## IEEE P802.15 Wireless Personal Area Networks

Project	IEEE P802.15 Working Group for Wireless Personal Area Networks (WPANs)	
Title	<b>TG3 D10 running comment resolutions</b>	
Date Submitted	[8 July, 2002]	
Source	[James P. K. Gilb] [Apparent Technologies] [9921 Carmel Mountain Rd. #247, San Diego, CA 92129]	Voice: [858-538-3903] Fax: [858-538-3903] E-mail: [gilb@ieee.org]
Re:	[]	
Abstract	[This document is a record of comment resolutions for LB17.]	
Purpose	[To provide a record of the comment resolution for LB17.]	
Notice	This document has been prepared to assist the IEEE P802.15. It is offered as a basis for discussion and is not binding on the contributing individual(s) or organization(s). The material in this document is subject to change in form and content after further study. The contributor(s) reserve(s) the right to add, amend or withdraw material contained herein.	
Release	The contributor acknowledges and accepts that this contribution becomes the property of IEEE and may be made publicly available by P802.15.

# 1. Comment resolution, Vancouver to Schaumburg

Figure 119 – MSC for reserving asynchronous data channel time. Discussed earlier, new MSC is below:

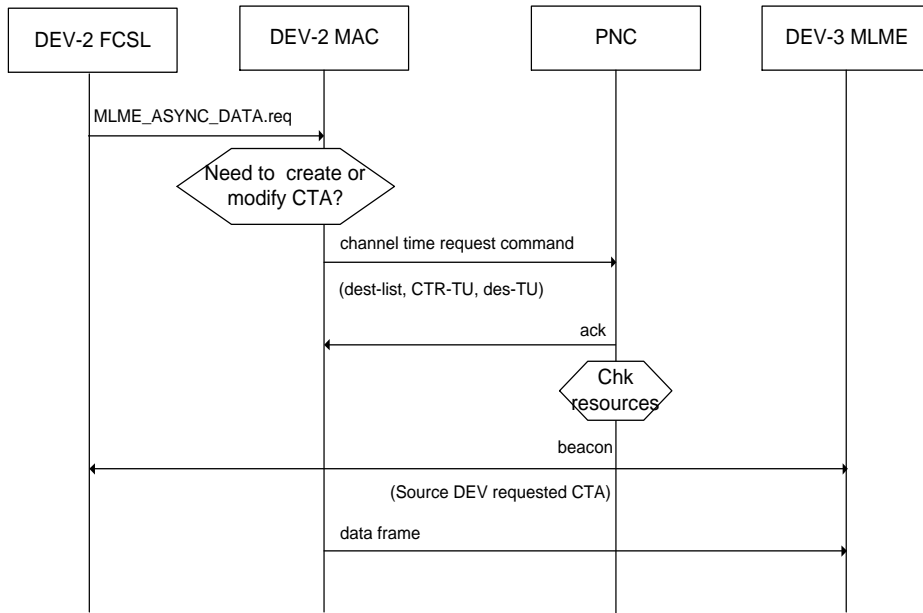
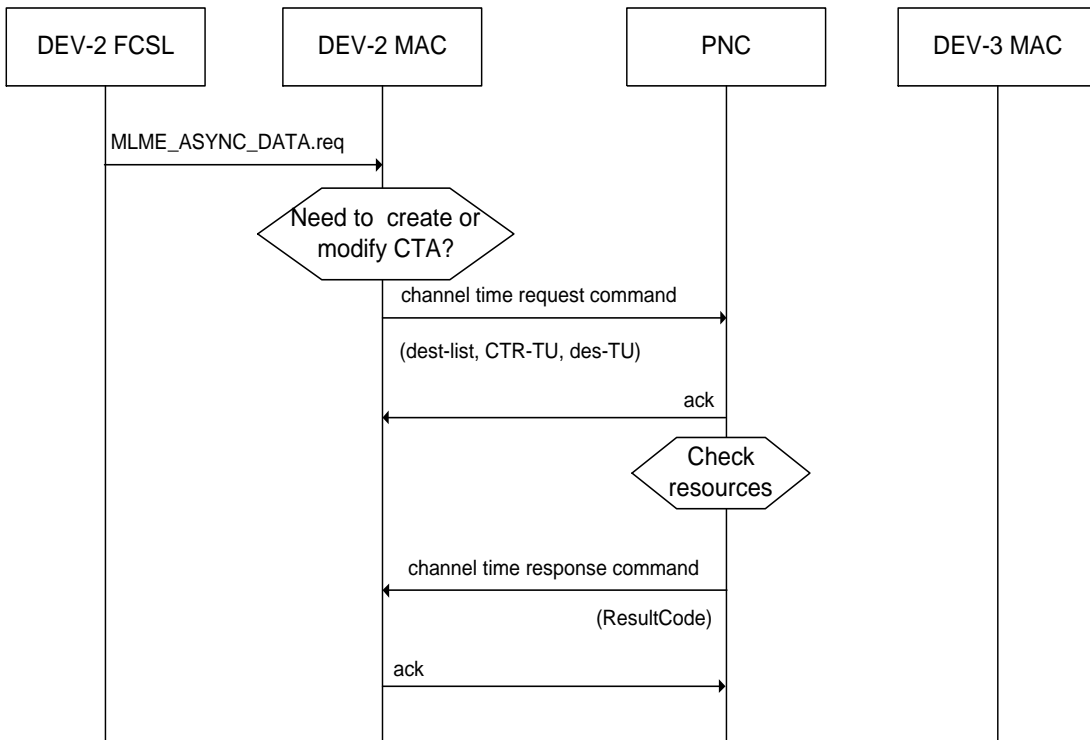
614, 652 (Gilb, T) The MLME-CREATE-CTA.req should be shown coming from the DEV-2 DME. What is "MAC-Q"? Also, the CL is no longer the packet CL but the FCSL (i.e. frame convergence sublayer). Consequently, change MAC-Q to be simply MAC. Change Packet CL to be FCSL in figure 4. **Accept in Principle** 1) replace MAC-Q and MLME with simply DEV-2 MAC. 2) Rename Packet CL to FCSL 3) Delete Figure 4 since it is duplicated in Figure 119. 4) Incorporate suggested changes identified in CID 327

914 (Bain, T) In figure 119, The PNC DME has the task of building the beacon. However, in the isochronous operation figures, the PNC MLME is shown to be building the beacon. Consequently, change the location of the build beacon element to the PNC MLME. **Suggest accept in principle** per CID 327

327 (Heberling, TR) Figure 119 is a flawed MSC of the Asynchronous channel time reservation process and data frame exchange. Consequently, delete the current MSC from this section of clause 8.5.2.1 and replace it with 02r0P802-15\_TG3-Asynch-channel-time-allocation.eps. **Suggest accept**.

Figure 1—MSC for a approved asynchronous channel time request

Figure 2—MSC for a denied asynchronous channel time request
